6. PUBLIC HEARING – Josh Dan, Associate Planner  
Conditional Use Permit 2021-22: A request to construct a fast-food restaurant measuring 1,315 sq. ft. with drive-thru and no indoor dining, upon a parcel measuring 1.1-acres in the Neighborhood Commercial (C-N) Zone. The project site is located on the northwest corner of East Tulare Avenue and South Lovers Lane (APN: 100-120-051). The project is Categorically Exempt from the California Environmental Quality Act (CEQA) pursuant to CEQA Guidelines Section 15303, Categorical Exemption No. 2021-38.

# REPORT TO CITY OF VISALIA PLANNING COMMISSION

SITE PLAN NO: 2020-198 - C  
PROJECT TITLE: Jack In The Box  
DESCRIPTION: Remove existing buildings and construct new drive thru restaurant  
APPLICANT: Mike Davis  
PROP. OWNER: Doucette Carl E.  
LOCATION TITLE: 1145 S. Lovers Lane  
APN TITLE: 100-120-051  
GENERAL PLAN: Commercial Neighborhood  
ZONING: C-MU – Commercial Mixed Use

**PROPOSED SITE PLAN**  
 SCALE: 3/32" = 1'-0"

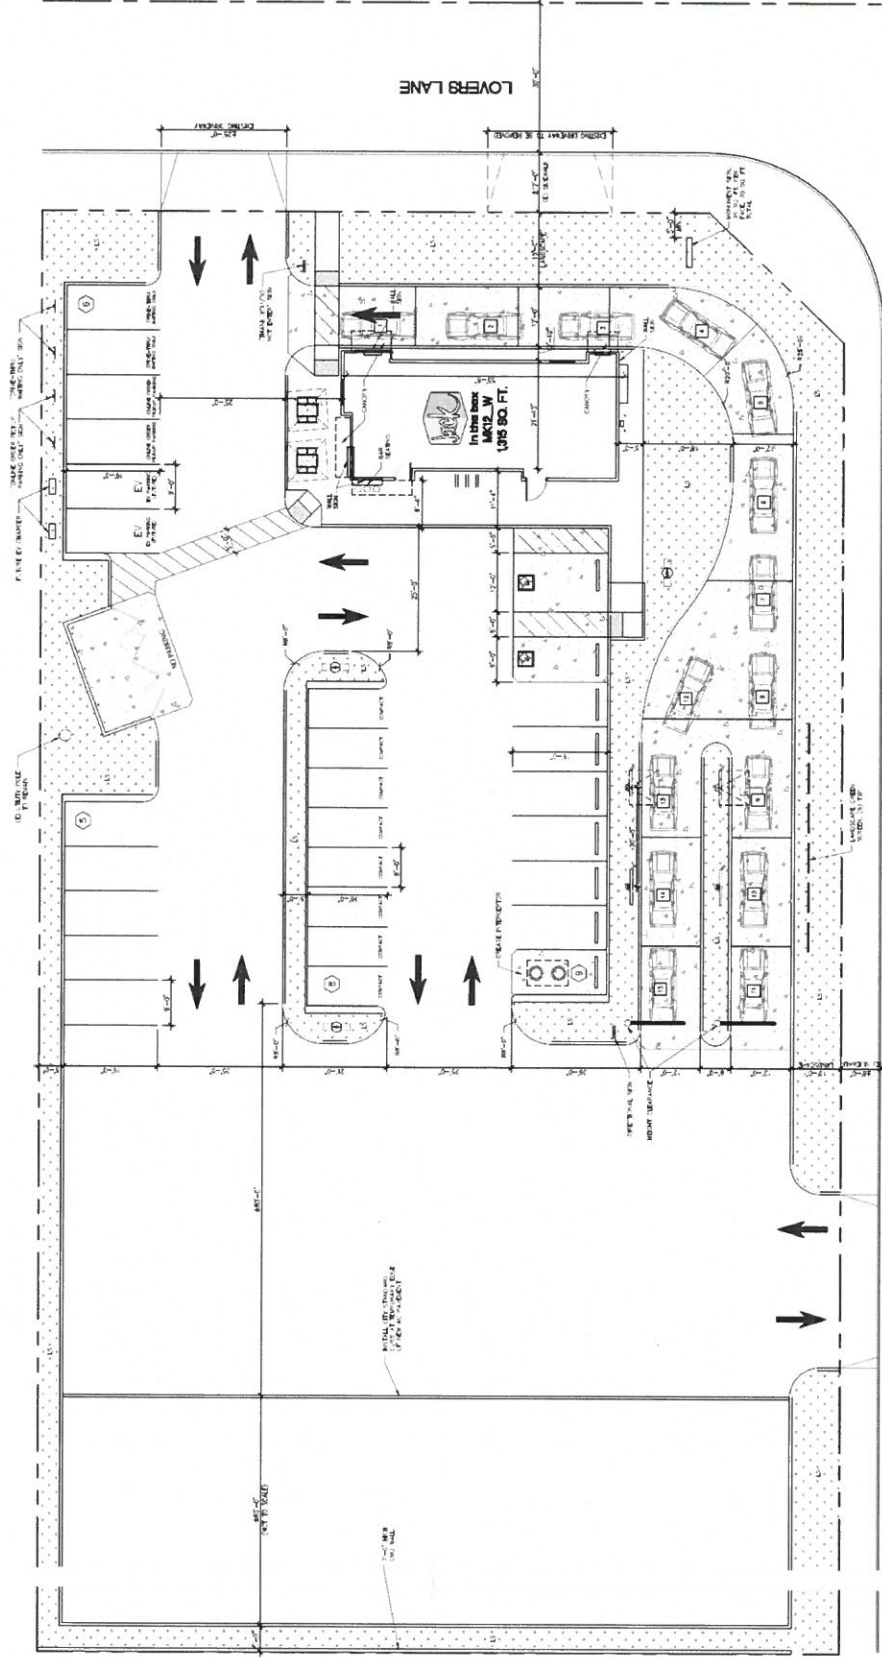
Site improvements, as depicted on the site plan (Exhibit "A"), do not include cross access to the vacant commercially zoned parcel to the north. As a result, staff has added Condition No. "5" stating that the applicant provide a paving stub-out to the north for future cross access.
